The following changes to the tender documents are effective immediately and will form part of the contract documents:

Interior Lease Fit-up for CIC Relocation to Victory Building
269 Main Street, Winnipeg, Manitoba

Slip Joint Detail

3. Drawing M1.3:

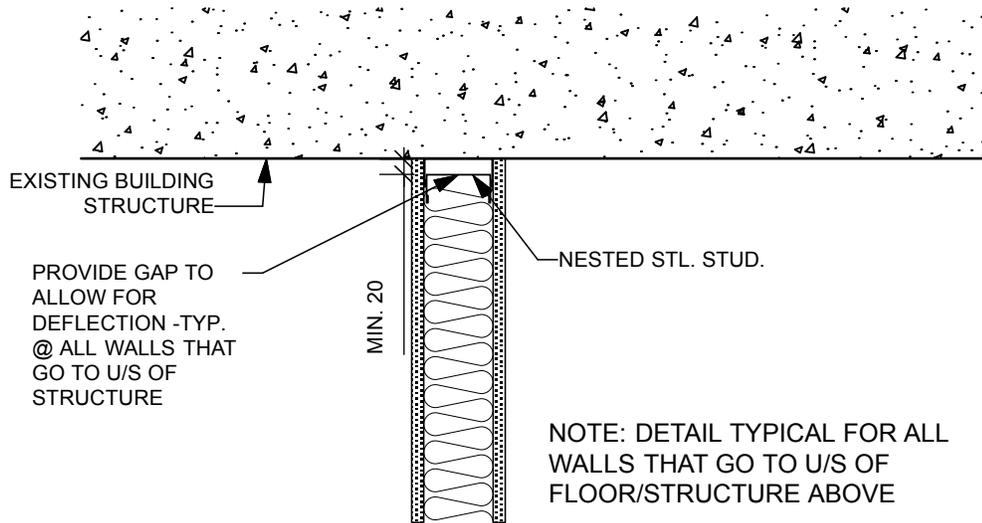
- a. Thermostats located along gridline B between 4 and 7 to be located on the west face of the column to avoid furniture interference.

- b. All thermostat locations to be coordinated with the general contractor to ensure no interference with furniture.
